**DEVON
ENERGY
CORPORATION**

July 12, 1996

New Mexico Oil Conservation Division
2040 S. Pacheco St.
Santa Fe, New Mexico 87505

Recently the New Mexico OCD issued Administrative Order No. WFX-687 granting permission for the expansion of the Keel - West Waterflood Project. As we discussed by telephone on July 3, 1996 there has been a misunderstanding of the requested injection interval. For example, the Well Data Sheet for the Keel "A" 28 states the following:

DEVON ENERGY OPERATING CORPORATION WELLBORE SCHEMATIC

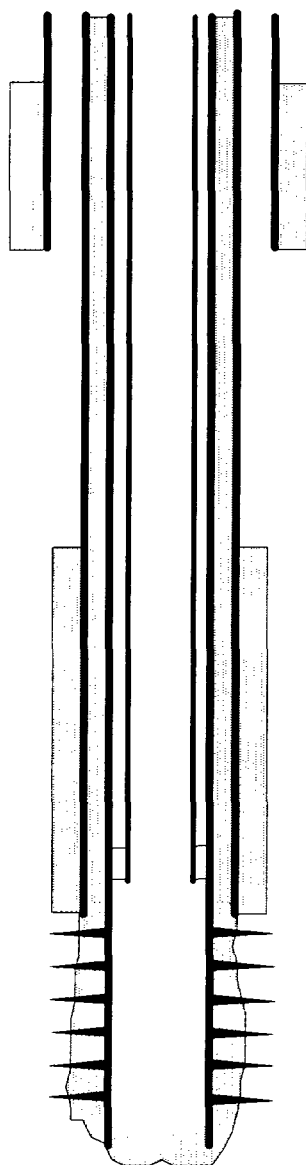
Finally, the well schematic for the C. A. Russell 6 proposed completion is now obsolete. Due to the poor condition of the 7" production casing Devon has elected to run a string of 4 1/2", 11.6#, J-55 casing inside the 7" casing and cement this string back to surface prior to commencing injection operations. Injection intervals will remain unchanged.

10 3/4" CASING, SET W/50 SXS. TOC @ 385'(CALC)

INJECTION INTERVAL: 2710'- 3650'

BAKER AD-1 PACKER @ +/-100' FROM TOP PERFORATION
7" CASING SET W/100 SXS. TOC @ 2402'(CALC)

PERFORATIONS THROUGHOUT INJECTION INTERVAL

4 1/2" CASING SET W/300 SXS. TOC @ SURFACE
TD @ 3650'
